World Forum for Harmonization of Vehicle Regulations**Working Party on General Safety Provisions****104th session**

Geneva, 15–19 April 2013

Regulation No. 46 (Devices for indirect vision)**Proposal for amendments to Regulation No. 46
(Devices for indirect vision)****Submitted by the expert from Japan ***

Figure 3(a)

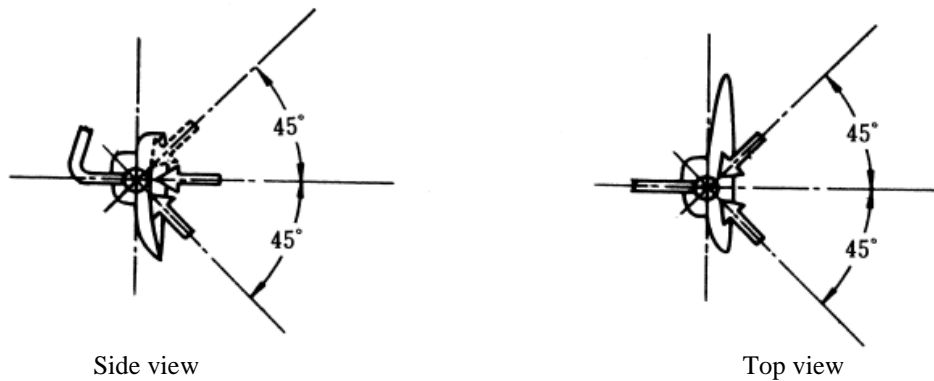
In the case of the interior mirror, apply a forward force in each of the following directions, to the centre of the rear-view mirror's direction-swivel section (see Figure 3(a)):

- (a) Direction parallel to the vehicle centre line;
- (b) Directions 45° to the left and right of the vehicle centre line on the horizontal plane; and
- (c) Direction 45° upward or downward of the horizontal line on the vertical plane parallel to the vehicle centre line.

Figure 3(b)

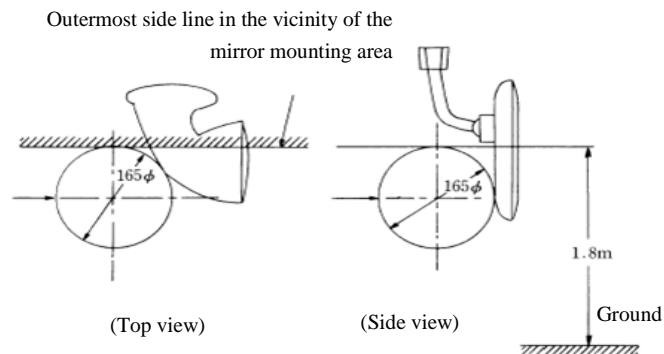
In the case of the exterior mirror, place a 165 mm diameter cylinder in such a way that the exterior of the cylinder comes in contact with the vehicle's outermost side line in the vicinity of the mirror mounting area, or the line drawn at a height of 2.0 m above the ground. Apply a rearward force in a direction parallel to the vehicle centre line, to the cylinder centre line (see Figure 3(b)).

Figure 3(c)

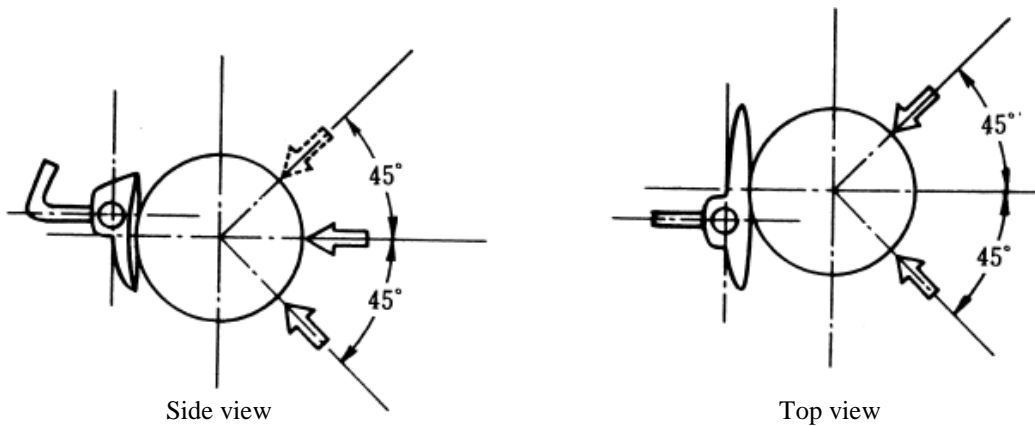
In the case of the interior mirror, place a 165 mm diameter spherical object in such a way that it comes in contact with the mirror surface centre, and apply a forward force in each of the following directions, to the spherical object centre (see Figure 3(c)):

- (a) Direction parallel to the vehicle centre line;
- (b) Directions 45° to the left and right of the vehicle centre line on the horizontal plane; and
- (c) Direction 45° upward or downward of the horizontal line on the vertical plane parallel to the vehicle centre line.

Figure 11

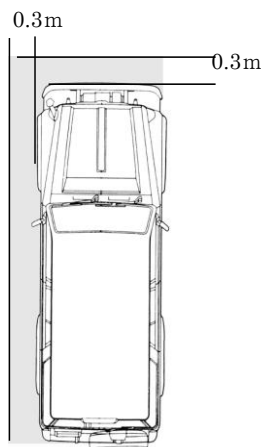
In vehicles of category M, a cylinder with a diameter of 0.3 m and height of 1.0 m that is in contact with the vehicle's front side and the lateral side on the passenger's side shall be partially visible using direct field of vision or any mirror including the surveillance mirror (see Figure 11). In this case, the eye-points in the direct field of vision are determined in Annex III. However, the blind area created by the A-pillar or exterior rear-view mirror as specified in Annex IV is excluded. If the field of vision cannot be achieved using these options, it may be achieved through installing a camera-monitor device, provided that it is easy to control the device to display images.

Figure 1

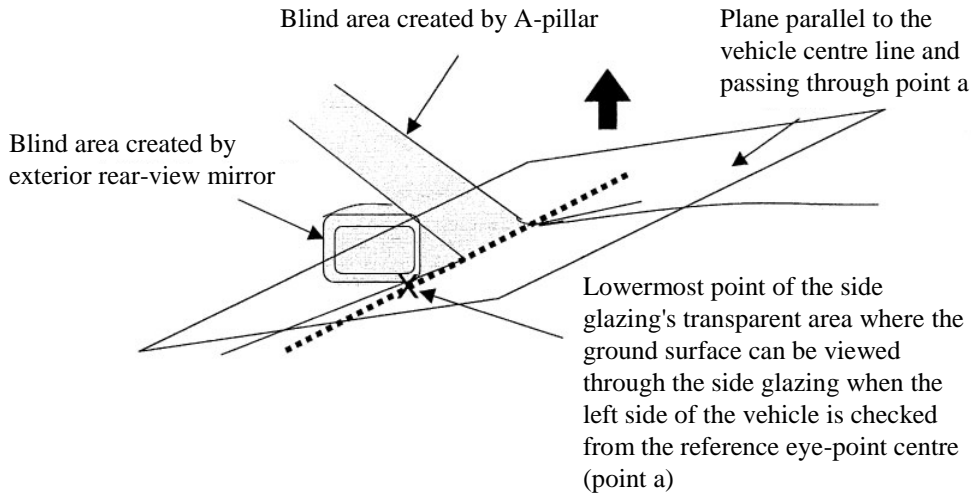
The range of the blind area created by the A-pillar or exterior rear-view mirror in paragraph 15.2.4.10. shall be an area that meets the following formula. In this case, if there are more than one blind area, each blind area shall meet the conditions of the formulae.

$$X \leq 0.292 \cdot L - 0.203$$

X (m): is the limit of the excluded area, i.e. the distance between the centre of a cylinder in contact with the front edge of the

blind area and the centre of a cylinder in contact with its rear edge.

L (m): is located inside the blind area created by the A-pillar or exterior rear-view mirror. Distance between the rear edge of a cylinder in contact with the rear edge of the blind area and the front edge of the rear wheel.
